SERVICE BULLETIN

DATE: February 20, 2025 Service Bulletin No. 661

SUBJECT: STD-35 Plain Washer Replacement

MODELS AFFECTED: All Lycoming Reciprocating Aircraft Engines

Figure 1
Locations of STD-35 Plain Washers on Engine Models in this Section

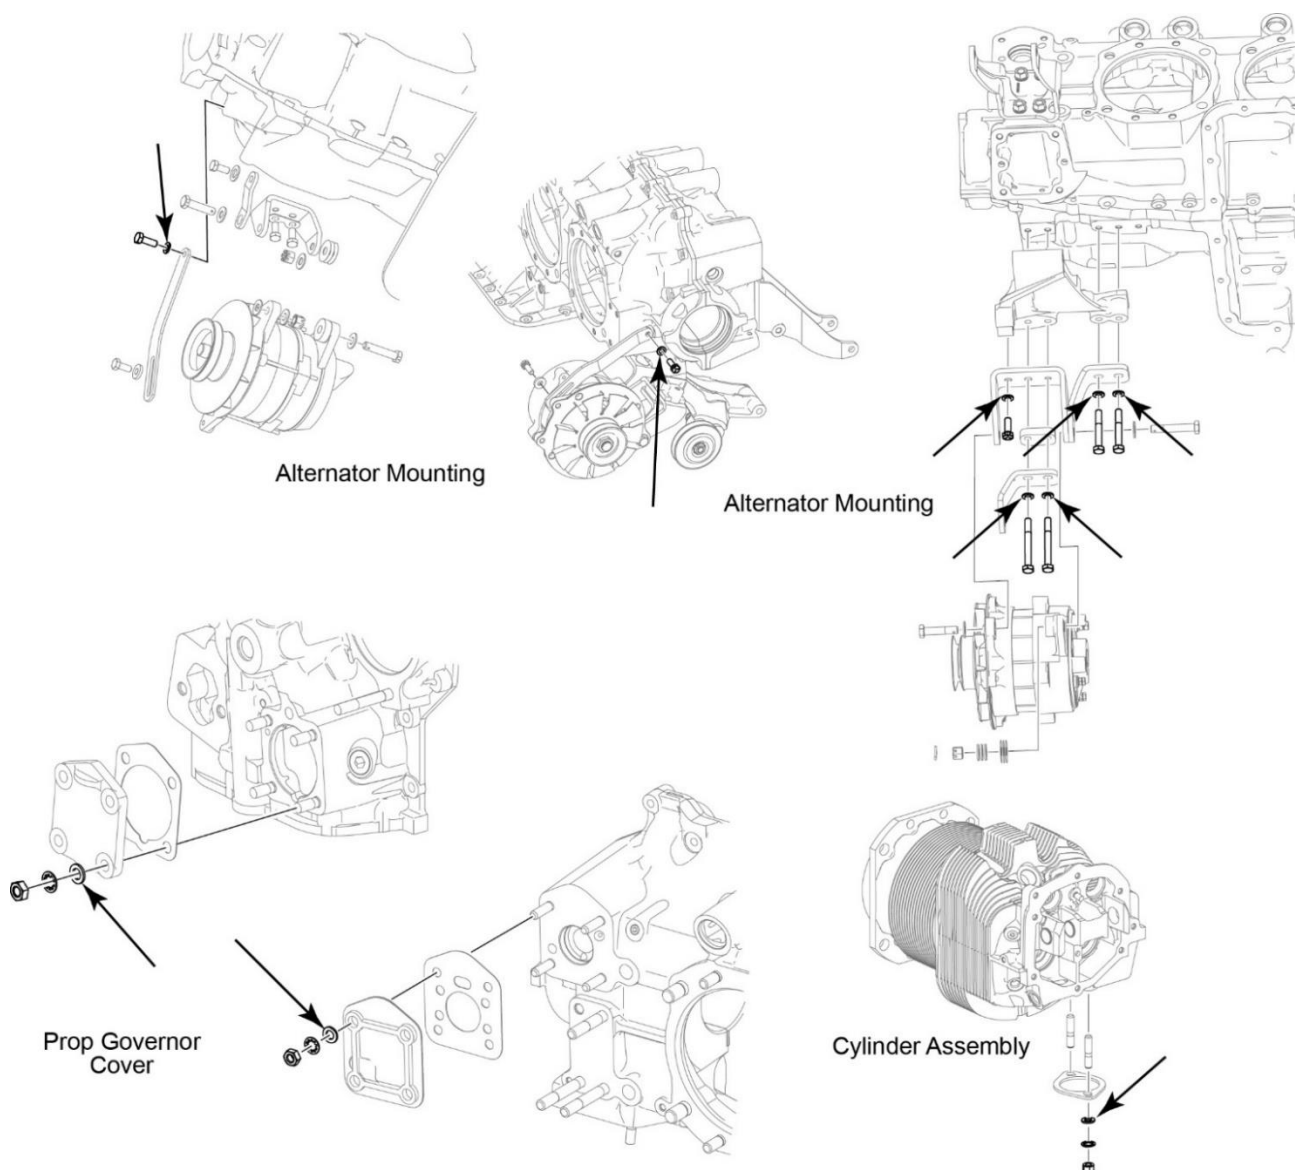
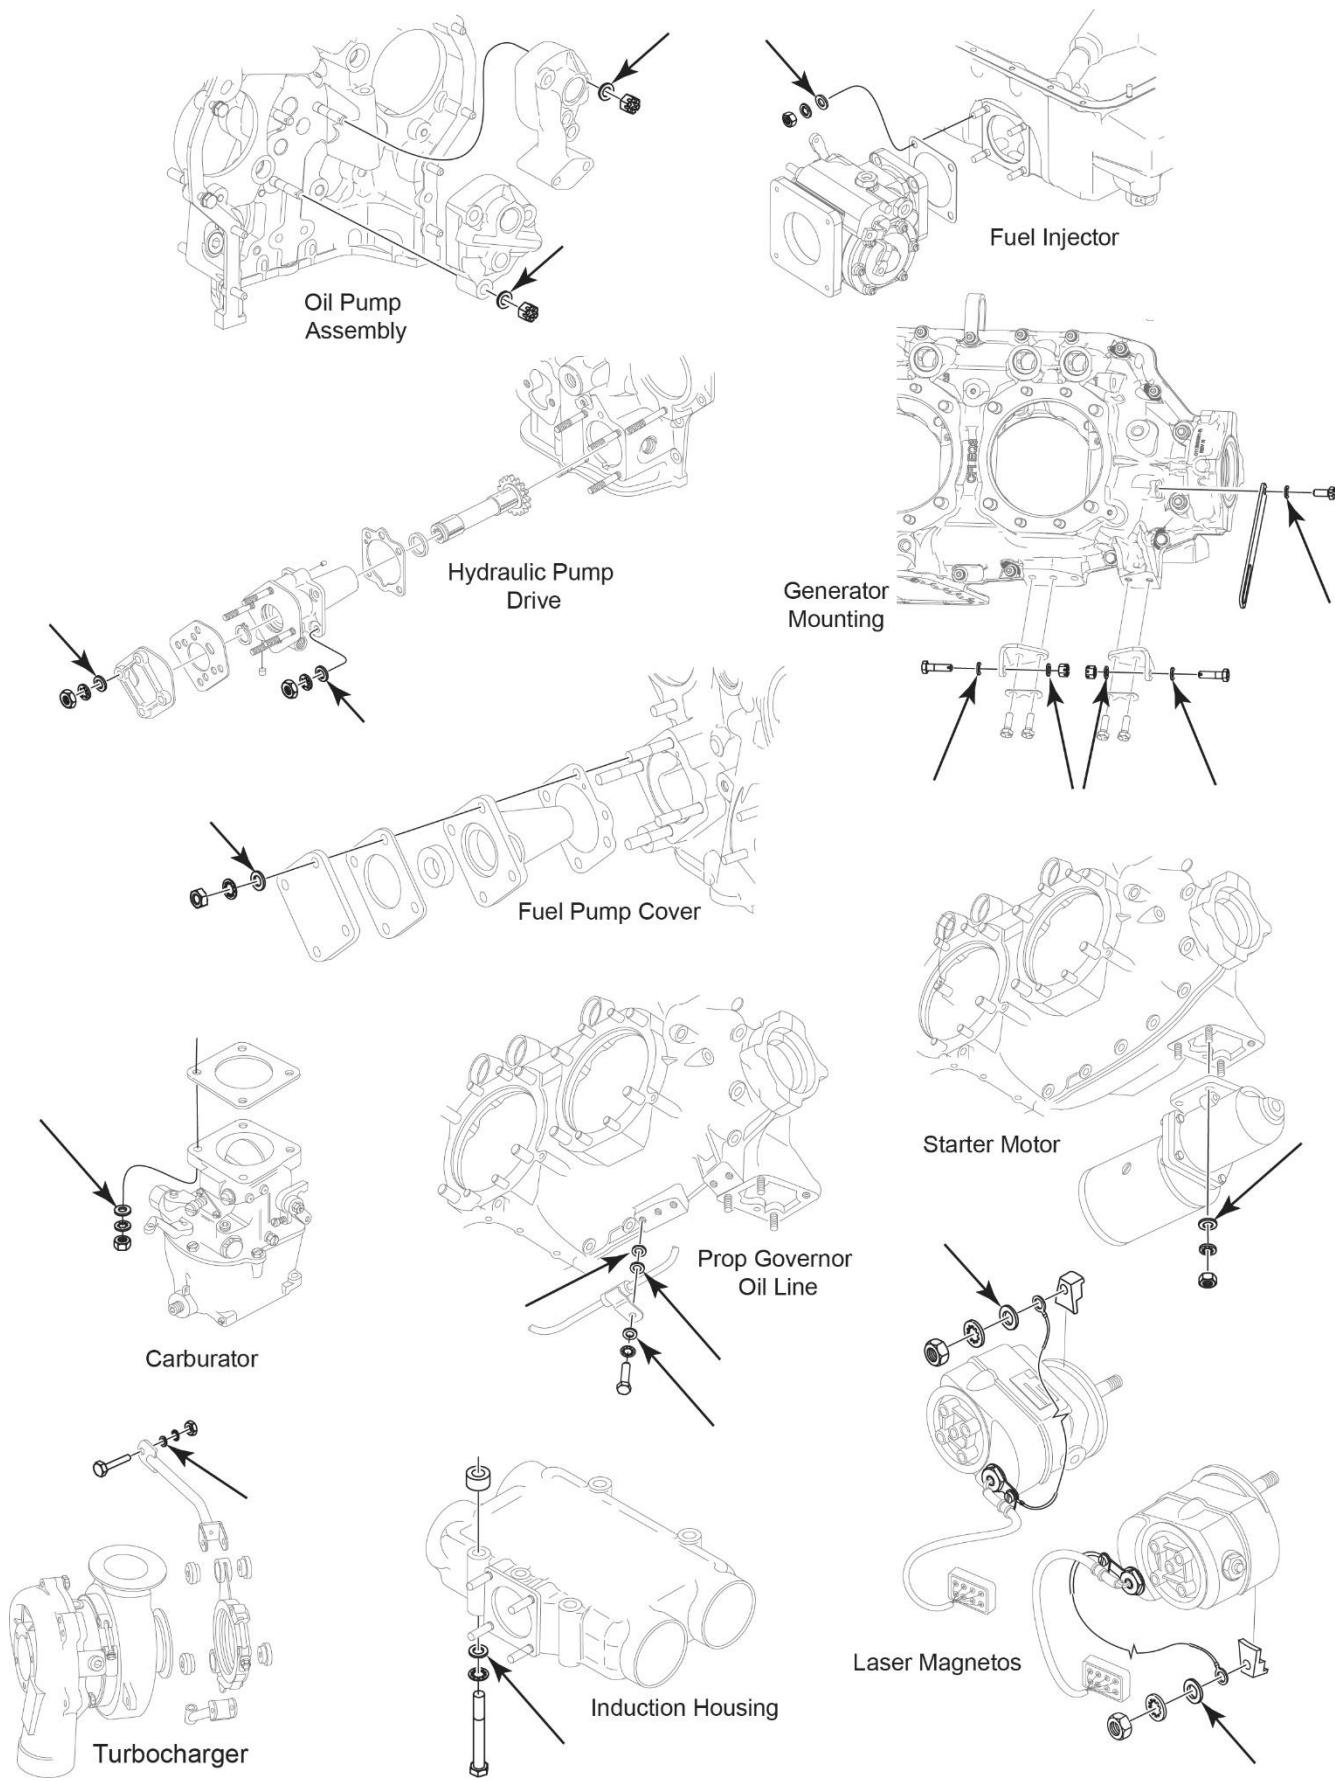
Figure 1 indicates common locations of STD-35 plain washers for engines in this section. Refer to the Illustrated Parts Catalog for your engine model for specific locations of the STD-35 plain washers. Refer to the appropriate engine maintenance manual, overhaul manual, or applicable ICA for torque values used during assembly.

At overhaul or the next maintenance event which requires removal of STD-35 plain washers, discard and replace the STD-35 plain washers, at the locations identified in each section, with conforming STD-35 plain washers, purchased after July 19, 2024.

Figure 2
Locations of STD-35 Plain Washers on Engine Models in this Section

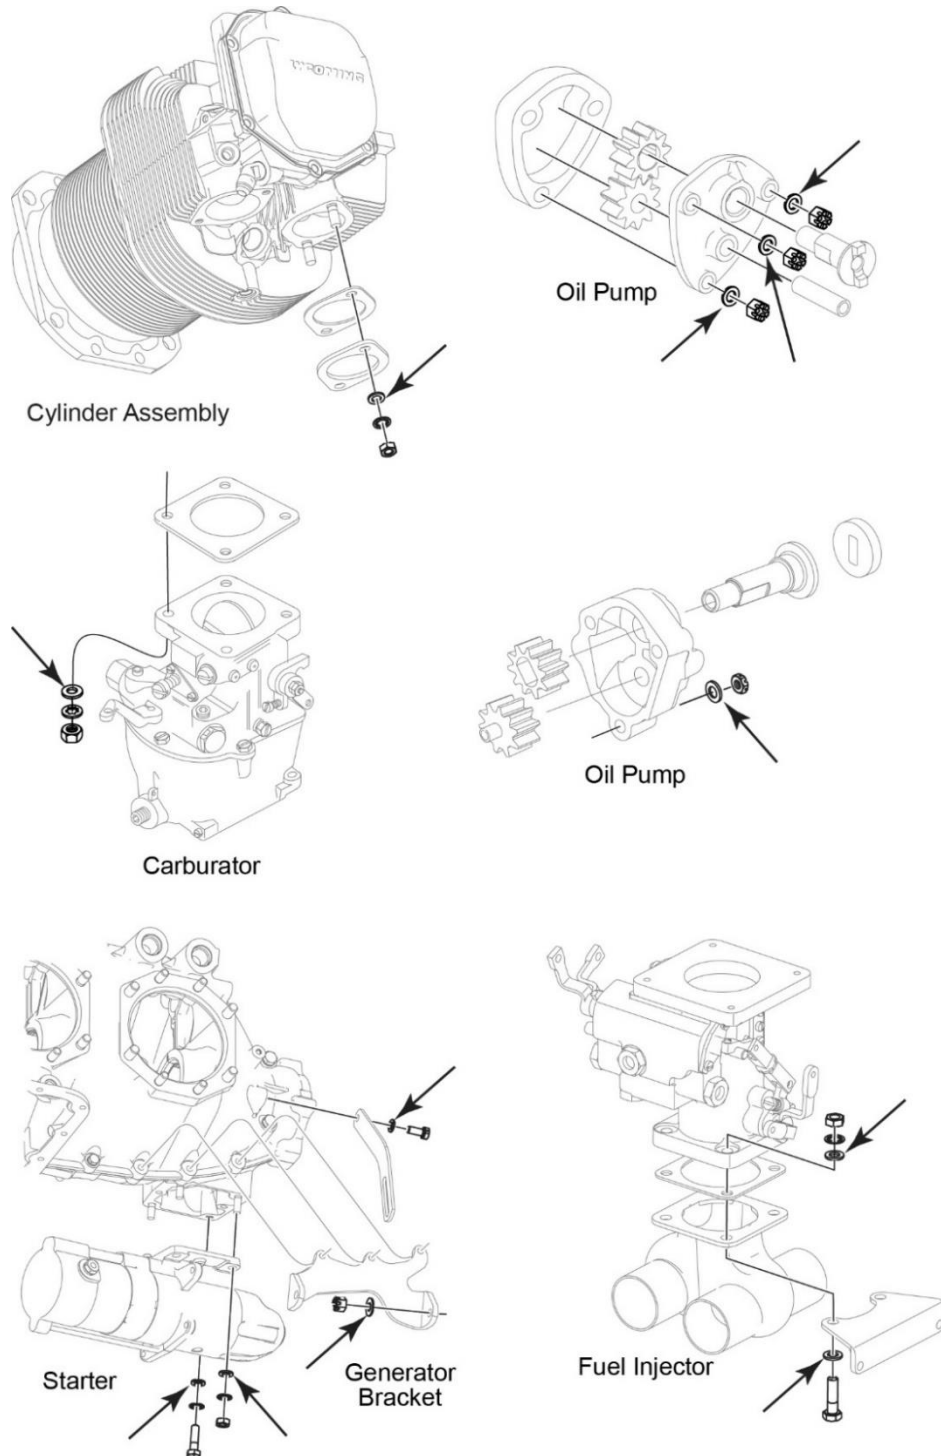
Figure 2 indicates common locations of STD-35 plain washers for engines in this section. Refer to the Illustrated Parts Catalog for your engine model for specific locations of the STD-35 plain washers. Refer to the appropriate engine maintenance manual, overhaul manual, or applicable ICA for torque values used during assembly.

Figure 3
Locations of STD-35 Plain Washers on Engine Models in this Section

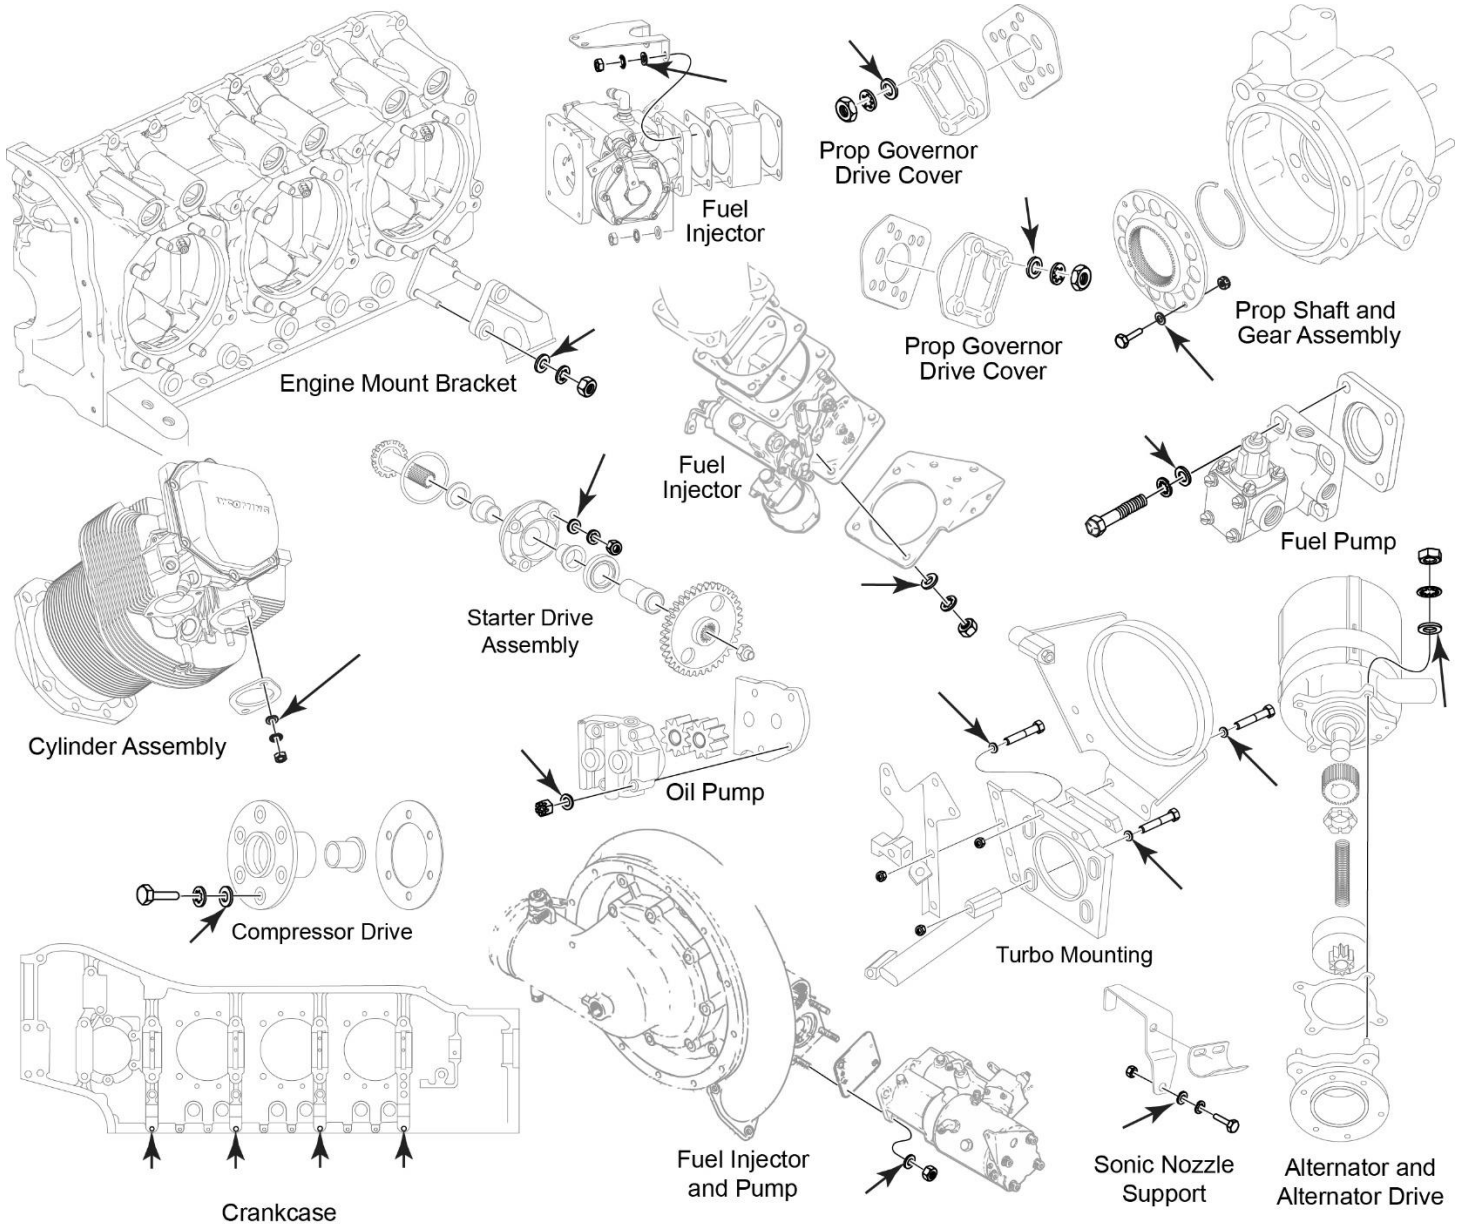
Figure 3 indicates common locations of STD-35 plain washers for engines in this section. Refer to the Illustrated Parts Catalog for your engine model for specific locations of the STD-35 plain washers. Refer to the appropriate engine maintenance manual, overhaul manual, or applicable ICA for torque values used during assembly.

Figure 4
Locations of STD-35 Plain Washers on Engine Models in this Section

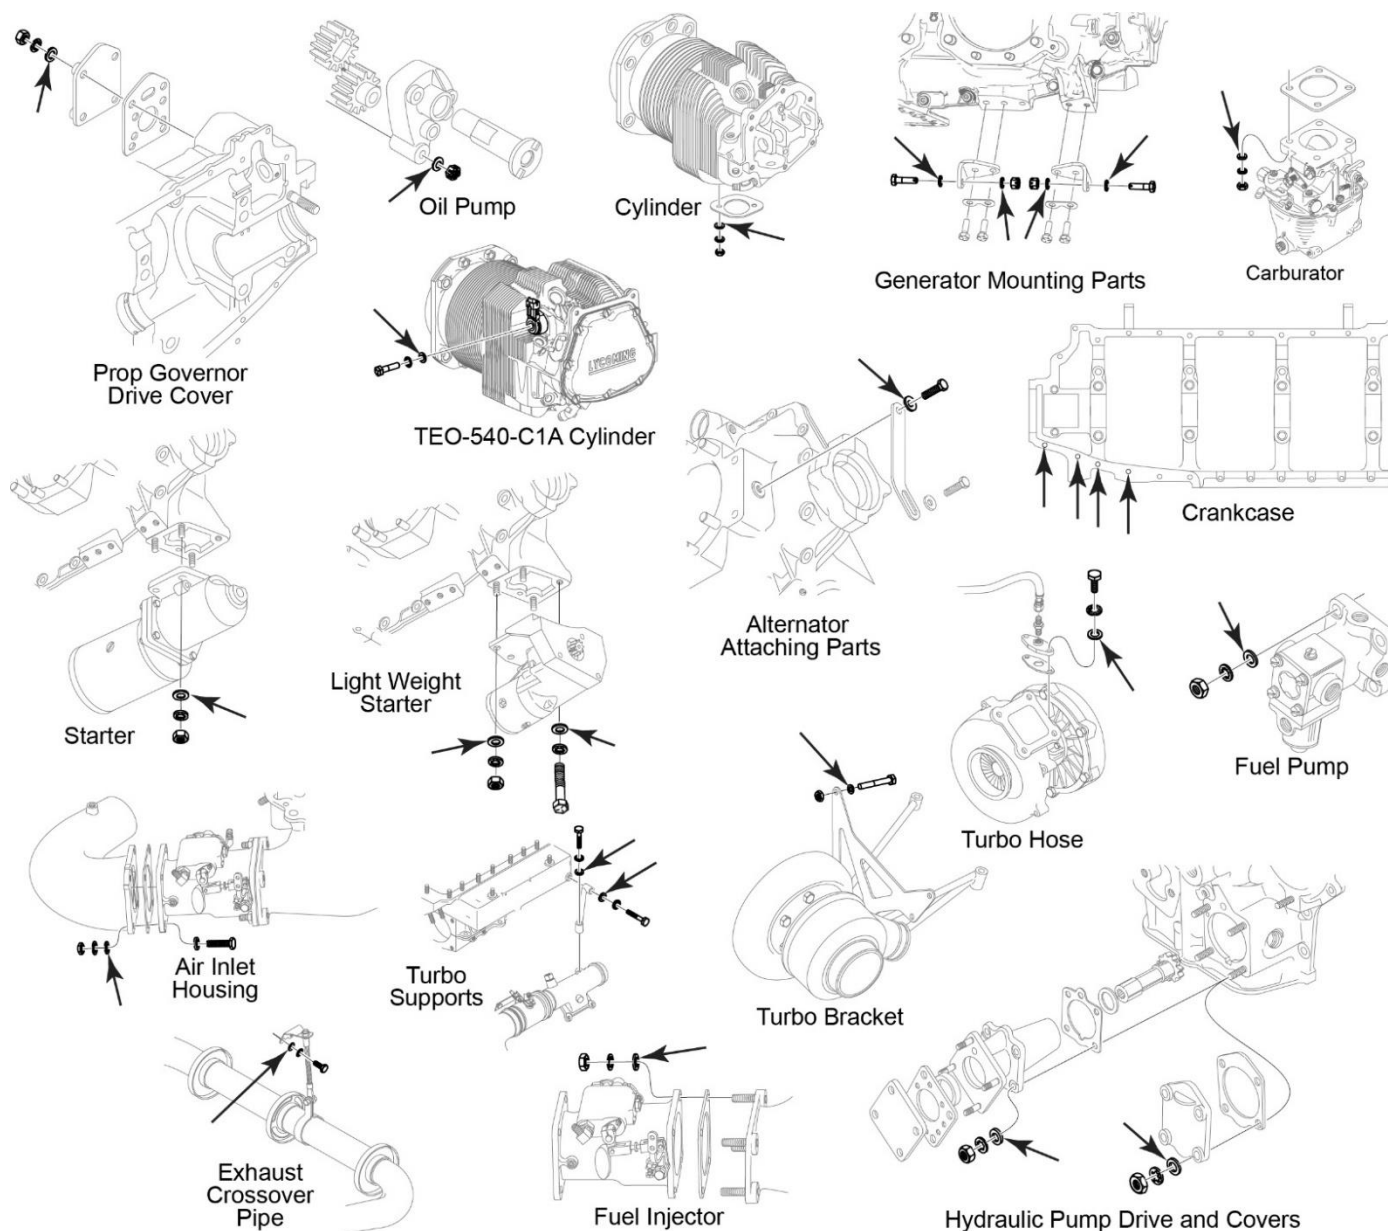
Figure 4 indicates common locations of STD-35 plain washers for engines in this section. Refer to the Illustrated Parts Catalog for your engine model for specific locations of the STD-35 plain washers. Refer to the appropriate engine maintenance manual, overhaul manual, or applicable ICA for torque values used during assembly.

NOTICE: On TEO-540-C1A engines, correct torque of the bolt that attaches the detonation sensor to the cylinder is necessary for proper sensor operation. Loss of torque could result in false detonation fault codes being indicated. Be sure to use conforming STD-35 plain washers, purchased after July 19, 2024, when installing detonation sensors. Refer to the latest revision of the *TEO-540-C1A Engine Maintenance Manual* for Fault Troubleshooting and Sensor Replacement.

Figure 5
Locations of STD-35 Plain Washers on Engine Models in this Section

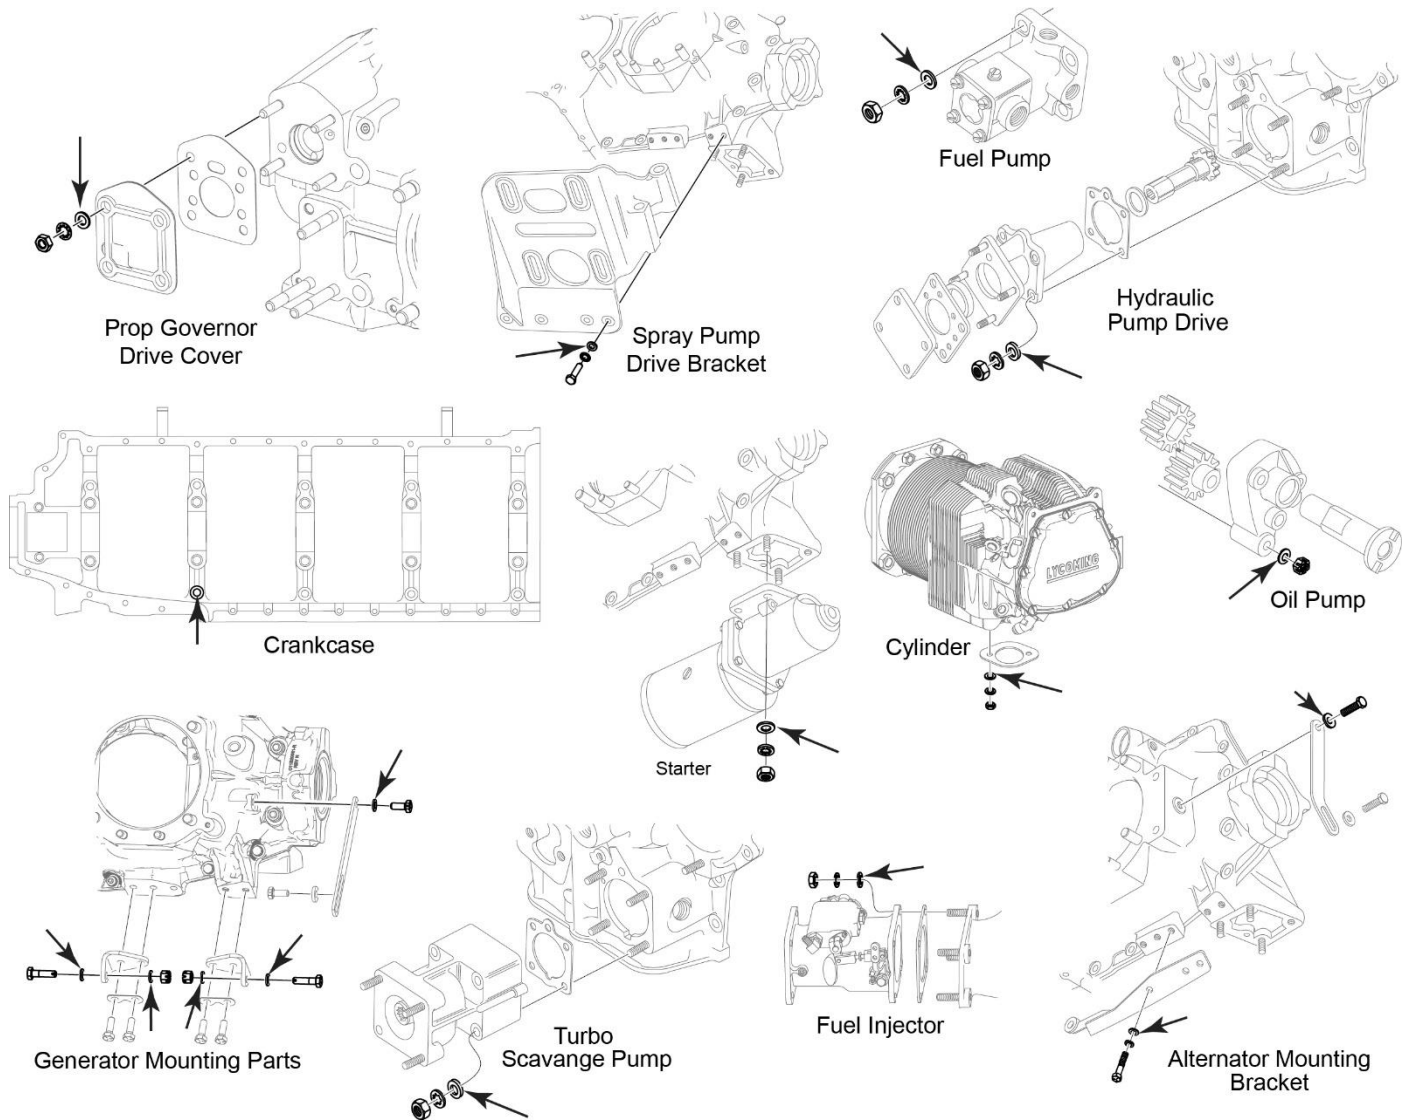
Figure 5 indicates common locations of STD-35 plain washers for engines in this section. Refer to the Illustrated Parts Catalog for your engine model for specific locations of the STD-35 plain washers. Refer to the appropriate engine maintenance manual, overhaul manual, or applicable ICA for torque values used during assembly.
